MODIFICATION RECOMMENDED

N5242AS-02

N5242AS PNA Series Microwave Network Analyzers

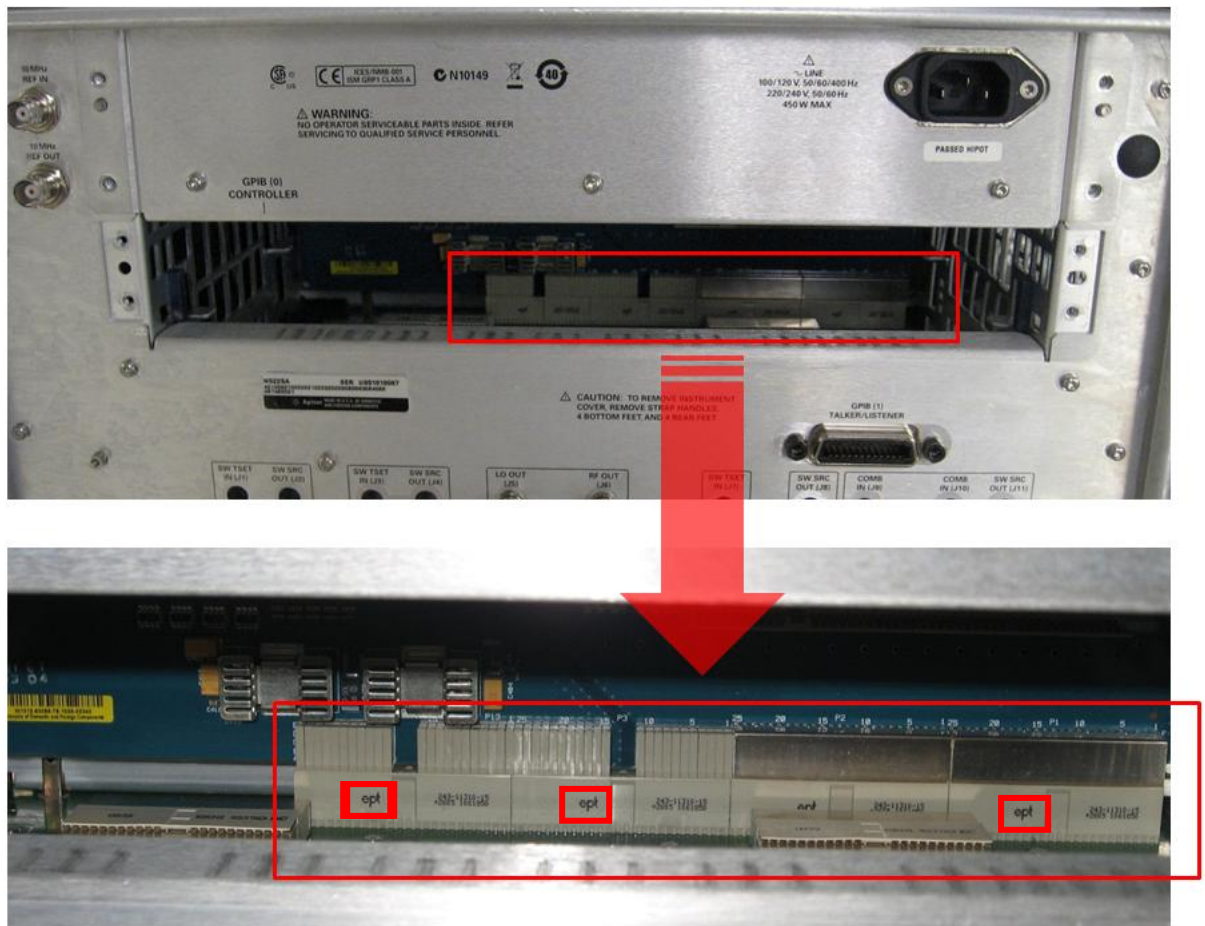
1. Remove the CPU assembly from the analyzer's rear panel. Refer to the PNA Service Guide chapter 7 section titled, "Removing and Replacing the CPU Board Assembly" for removal and reinstallation procedures. To view the online Service Guide, see the numbered list on the next page for instructions.
2. As per the photo below, inspect the system motherboard connector to see if it has one or more "ept" logos.

3. If the connector has one or more “ept” logos, return the analyzer to Agilent for replacement of the system motherboard. If the connector does not have one or more “ept” logos, email support_ctd-soco_support@agilent.com, providing the analyzer model and serial number and details of the malfunction symptoms.

4. *For Agilent Service Technicians only:* Only new boards without “ept” logos should be installed. Before installing the new board, look to see if it has one or more “ept” logos. If so, email support_ctd-soco_support@agilent.com, providing the analyzer model and serial number. Wait for further instructions in an email reply. New boards without “ept” logos can be installed.
For installation instructions, refer to the PNA Service Guide chapter 7 section titled, “Removing and Replacing the System Motherboard.” To view the online Service Guide, see the numbered list on the next page for instructions.
